Date: November 10, 2003
Architect's Project No.: 03034

**ADDENDUM NO. 4
TO
CONTRACT DRAWINGS AND SPECIFICATIONS
FOR
GULF OF MAINE RESEARCH LABORATORY
Portland, Maine**

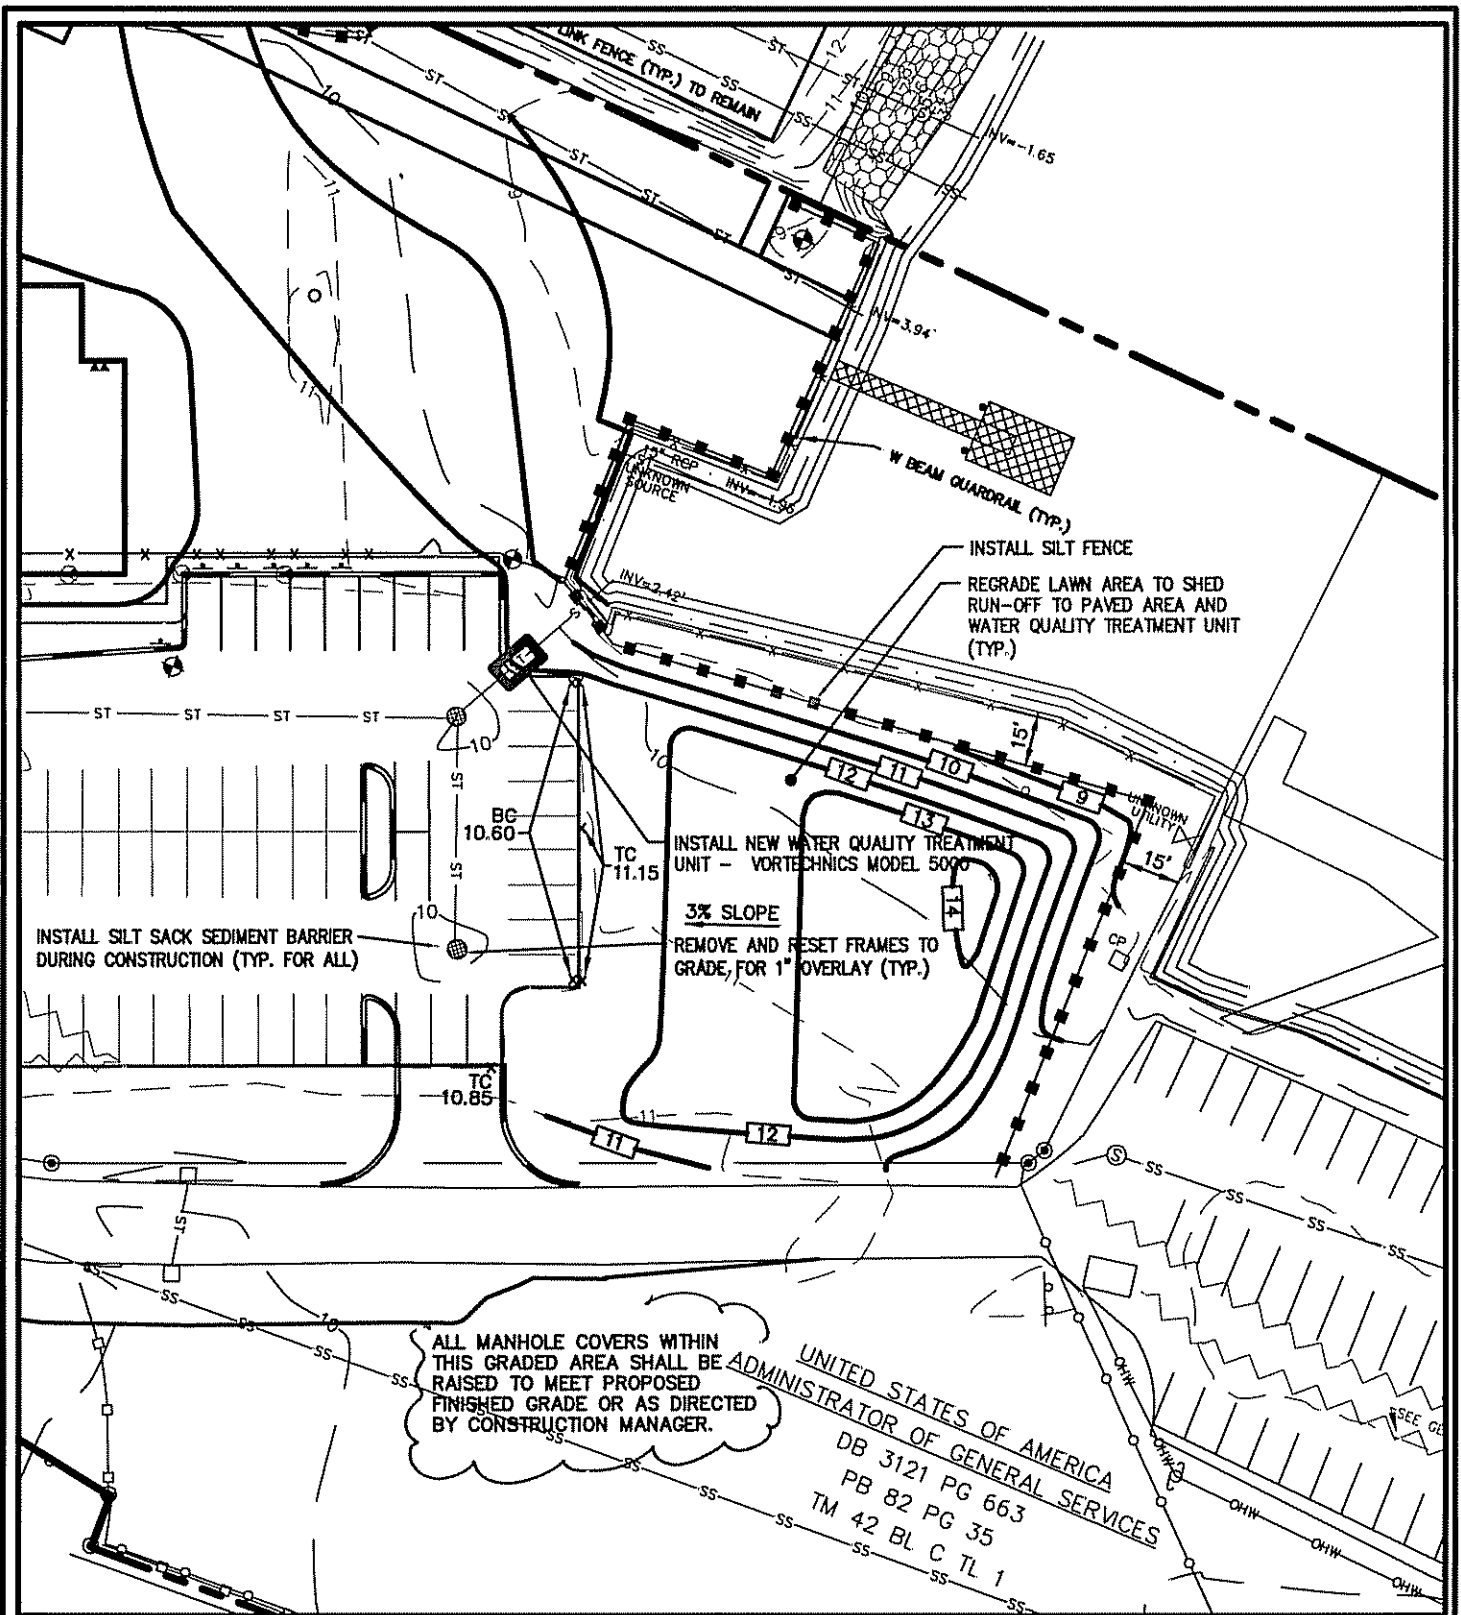
ALL MANHOLE COVERS WITHIN THIS GRADED AREA SHALL BE RAISED TO MEET PROPOSED FINISHED GRADE OR AS DIRECTED BY CONSTRUCTION MANAGER.

H SEAWATER RISER DETAIL
 SW114 SCALE: NTS

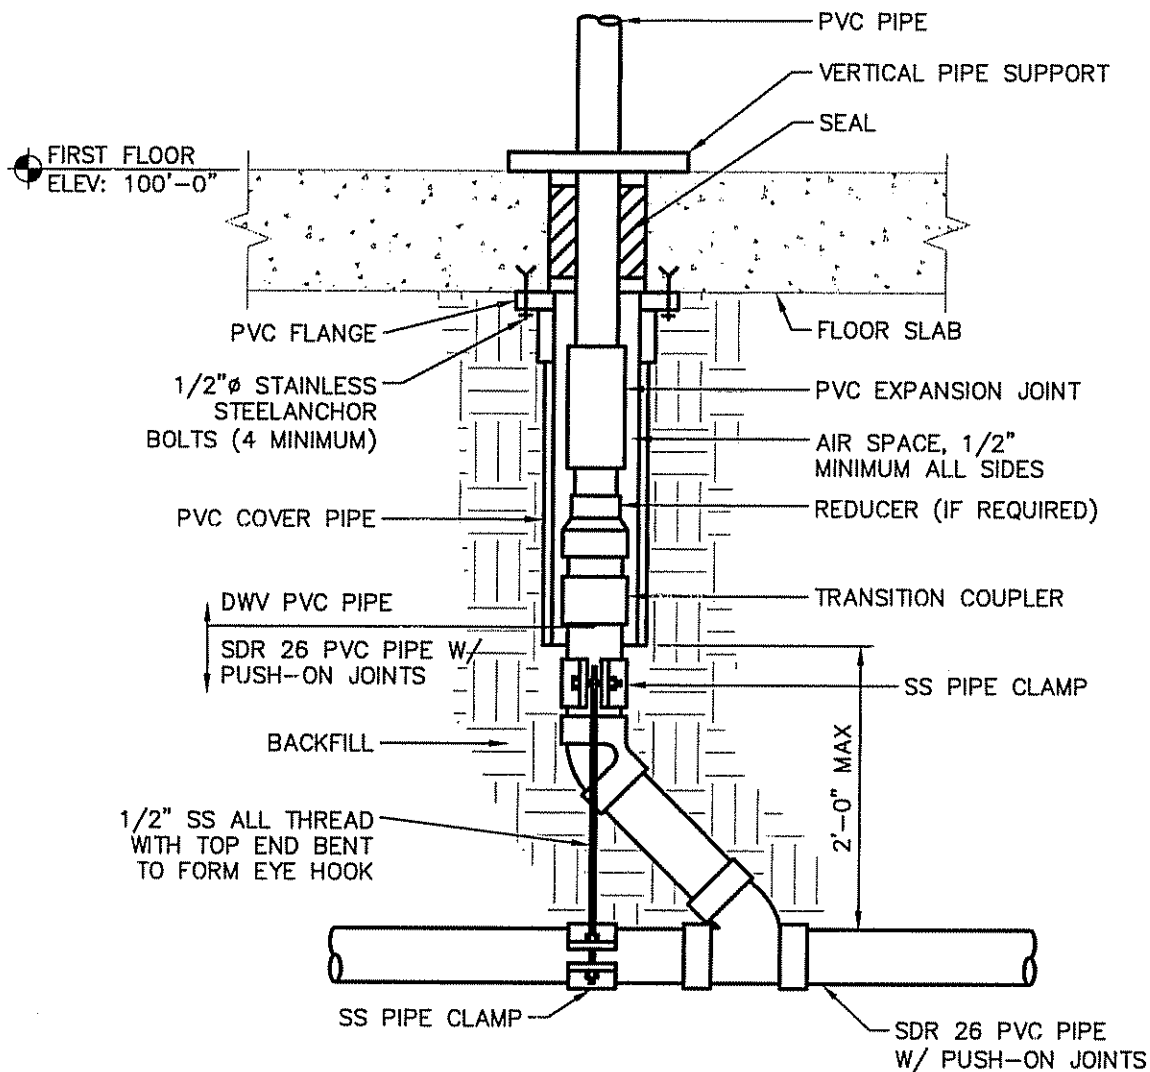
22. Drawing Sheet SW104:
 - A. Change elevation of FSW and TSW piping from "APPROX. INV. EL. 108'-0"" to read: "APPROX. INV. EL. 108'-6"".
 23. Drawing Sheet SW108. Delete detail "H – Seawater Riser Detail" and replace with detail "H – Seawater Riser Detail" as shown on attached sketch ADD4-SW1.

REVISED DETAIL H/SW108

E-2

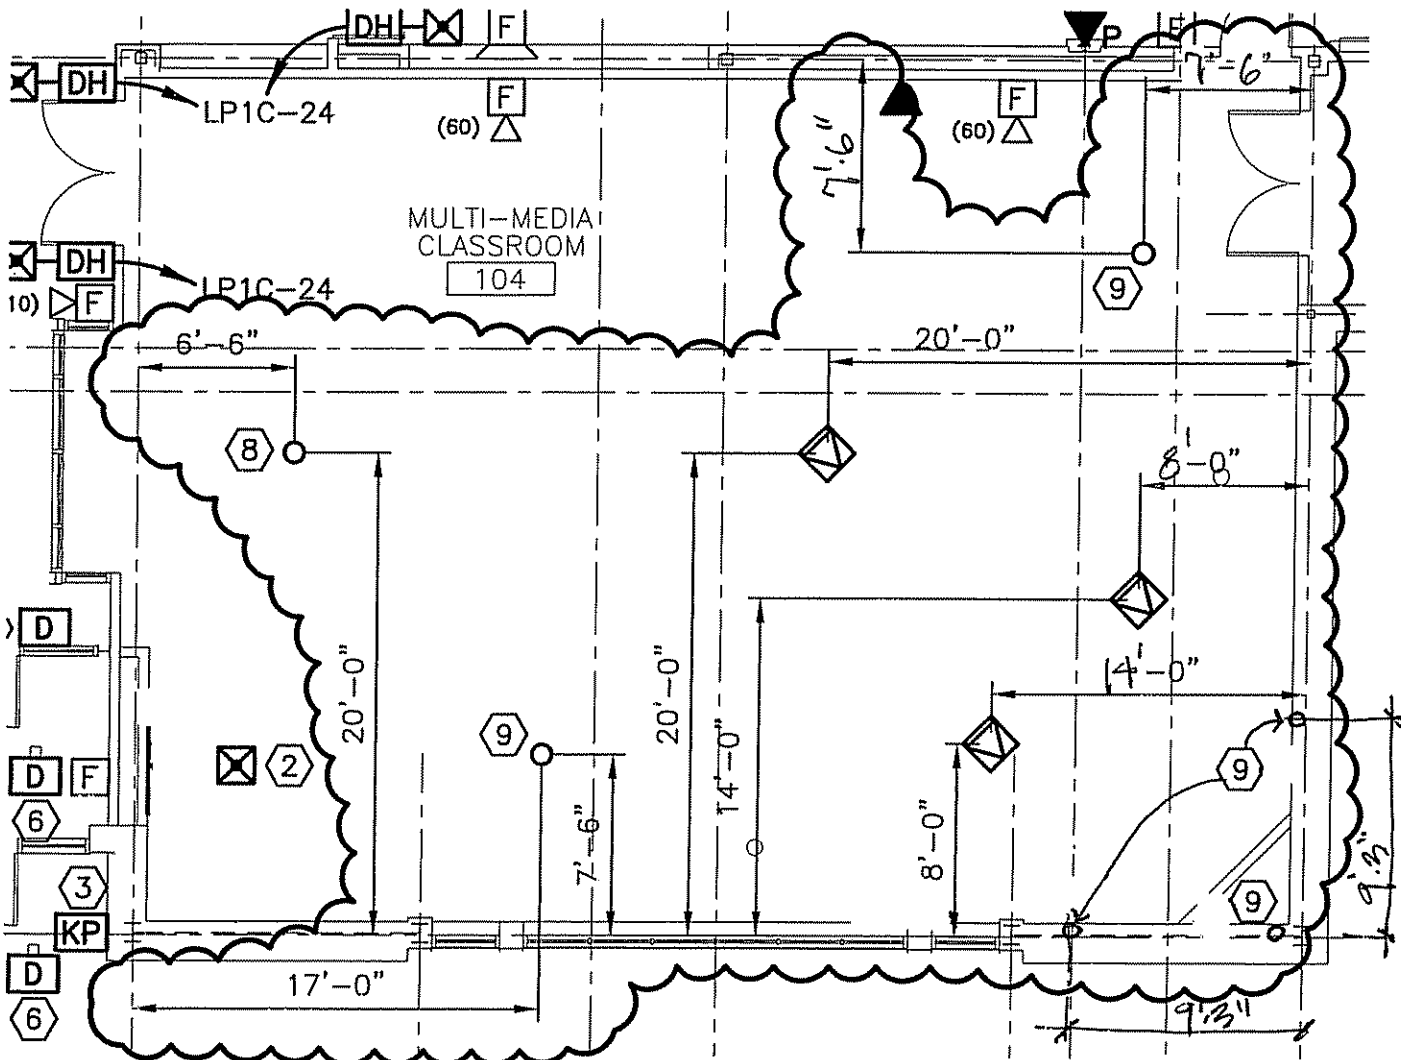
27. Drawing Sheet EY101. Revise data outlets as shown in attached sketch E2.

8) PROVIDE (2)-2" CONDUITS BETWEEN SCHOOLING TANK AND EQUIPMENT RM. 202

9) PROVIDE (1)-1" CONDUIT BETWEEN LAB VENTURE STATION AND EQUIPMENT RM. 202
